15 August 2024

Project/File: 304600135

**RESPONSES TO SYDNEY WATER COMMENTS ON THE STAGE 2 FLOOD IMPACT  
ASSESSMENT, WESTLINK INDUSTRIAL ESTATE AT 290-308 ALDINGTON ROAD, 59-62  
ABBOTTS ROAD & 63 ABBOTTS ROAD, KEMPS CREEK**

**Figure 1 Revised Subcatchment Boundaries for Stage 1 and Stage 2 of the Westlink Industrial Estate (Source: AT&L, 2024)**

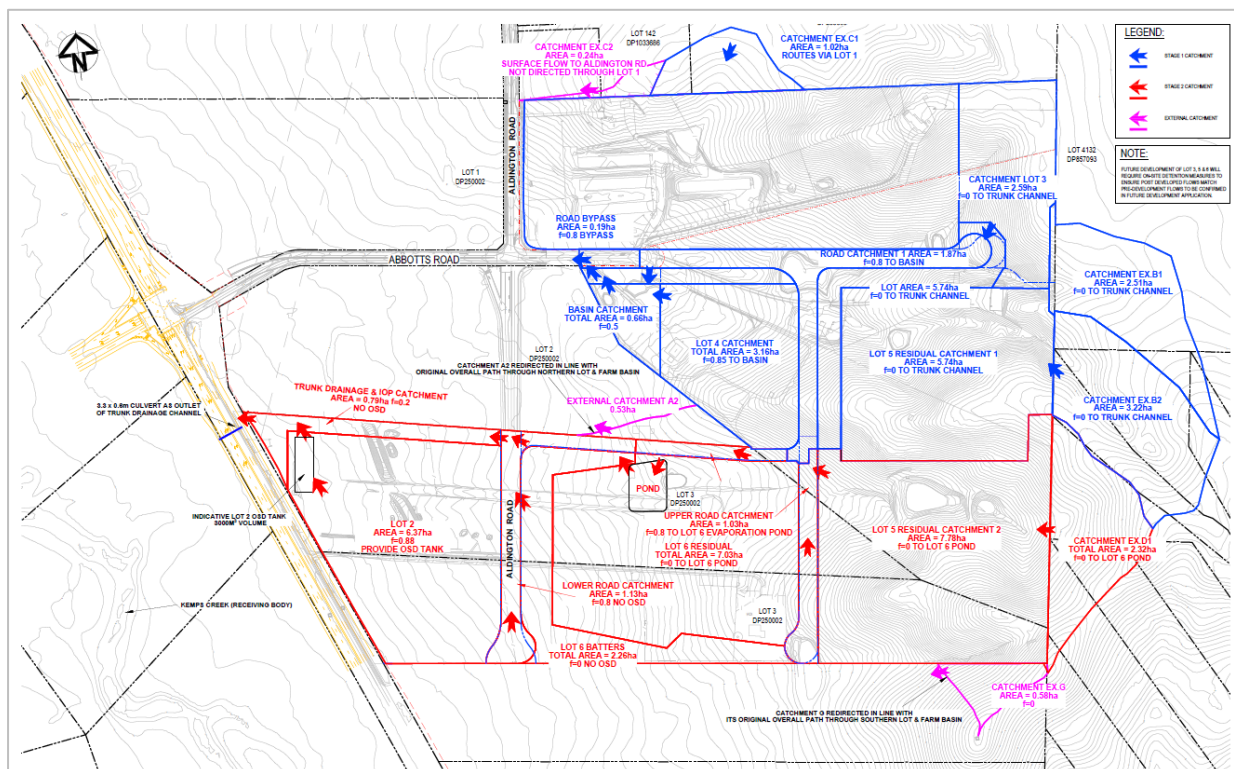
*The hydrology base model should adopt the same loss model as the adopted Wianamatta South Creek model*

- The 2023 hydrological model of Stage 1 and Stage 2 conditions was updated based on the revised subcatchment boundaries provided by AT&L (see Figure 1) and drainage system details provided by AT&L.
- The adopted imperviousness for the proposed development was 85%.
- Design rainfall and storm burst patterns were obtained from ARR1987 for 2 yr ARI, 20 yr ARI, 100 yr ARI, 200 yr ARI and 500 yr ARI events.
- The 2023 rainfall losses were retained, namely for the 2 yr ARI, 20 yr ARI, 100 yr ARI, 200 yr ARI and 500 yr ARI events the adopted initial rainfall loss = 15 mm and continuing rainfall loss = 1.5 mm/h.

The impervious percentage has been adjusted to 85%.
